UNITED STATES
NUCLEAR REGULATORY COMMISSION
WASHINGTON, D. C. 20555

SUBJECT: ADMINISTRATIVE ORGANIZATIONAL CHANGES

Oyster Creek Nuclear Generating Station

Amendment No. 68
License No. DPR-16

FIGURE 6.2.2
ON-SITE ORGANIZATION

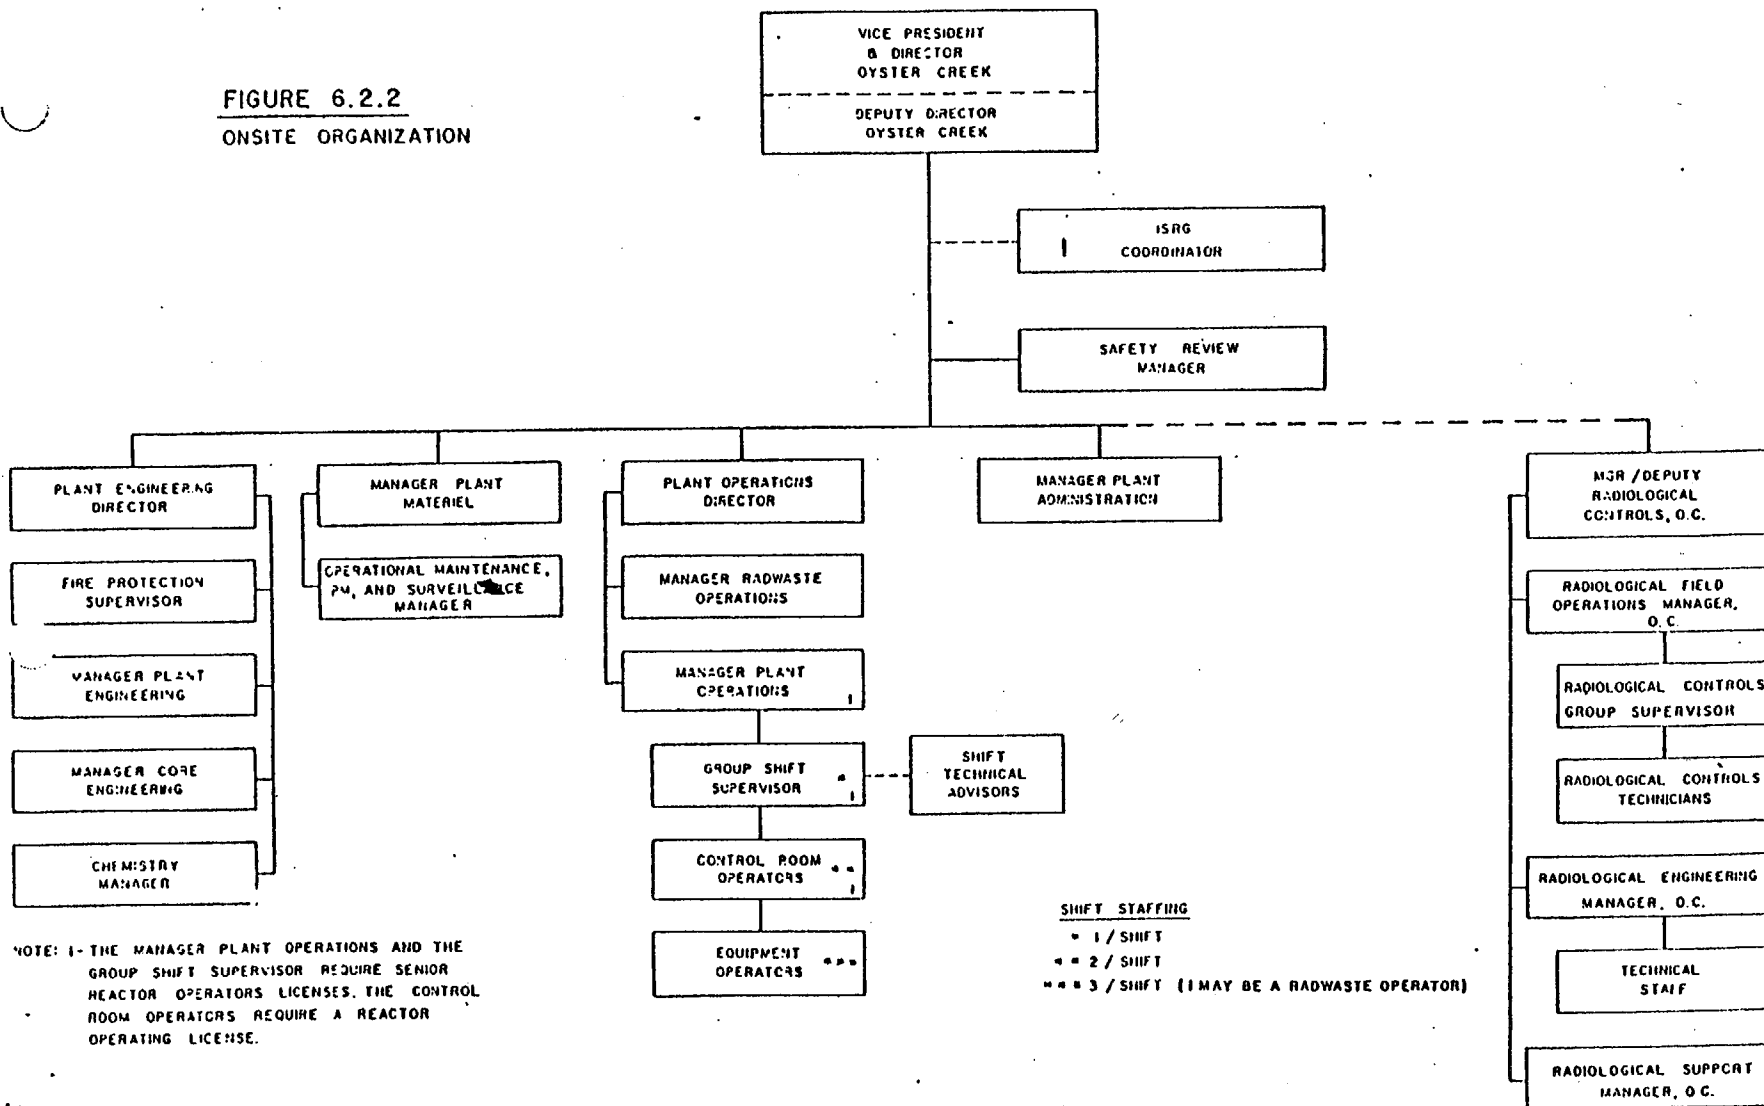
The amendment authorizes changes to the administrative organization at the Oyster Creek plant by allocating personnel between the Maintenance and Construction Division and a newly established Plant Material Department.

GPU proposed Technical Specification changes would revise various organizational positions and responsibilities. Specifically preventive maintenance would be the responsibility of the Plant Material Department, and corrective maintenance would be the responsibility of the Maintenance and Construction Division and would include all modifications, repairs and construction activities. The position of Manager Plant Maintenance would be retitled, Manager Plant Material; the position of Preventive Maintenance Manager would be retitled, Operational Maintenance Preventive Maintenance and Surveillance Manager; and the position of Instrument Maintenance Supervisor would be retitled, Area Supervisor Instrument and Computer Maintenance. In each case the qualifications for those positions would remain the same. In addition, the responsibilities and qualifications for the Maintenance and Construction Director would be added. GPU has defined the qualification requirements of this position to be equivalent and identical to that of the position of Manager Plant Material. The number of plant personnel required to be members of the Plant Operations Review Committee (PORC) would remain the same.
